Alaska Cruise Ship Wastewater Science Advisory Panel

Vendor Information Inquiry Responses

EVAC ZODIAC KUBOTA

RWO GmbH MARINE WATER TECHNOLOGY

Figure 1. Laboratory set-up used for testing of EVAC's proposed metal removal system.

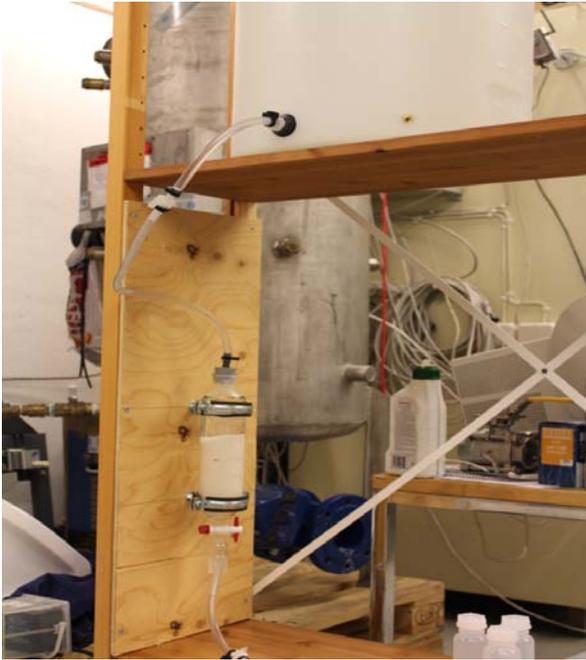
EVAC provided performance data for their proposed metal removal system in the form of laboratory study results. Figure 1 is a photograph of the laboratory testing set-up.

Influent for the test runs was a matrix of metals in de-ionized water. Test results are listed in Table 1. Testing of the metal removal system using matrices of metals in permeate from a small (16 person) membrane bioreactor is ongoing.

The metals removal performance study was conducted in a laboratory setting; therefore the Vendor identified that the results of the study could be affected by:

- Organic matter effects of the influent (polisher) on the polisher removal rate.
- Role of changing pH and metal precipitation.
- This results are obtained from scale laboratory setting, real world performances (residual concentrations) not known.
- Possible uncertainties when used in ship board application.
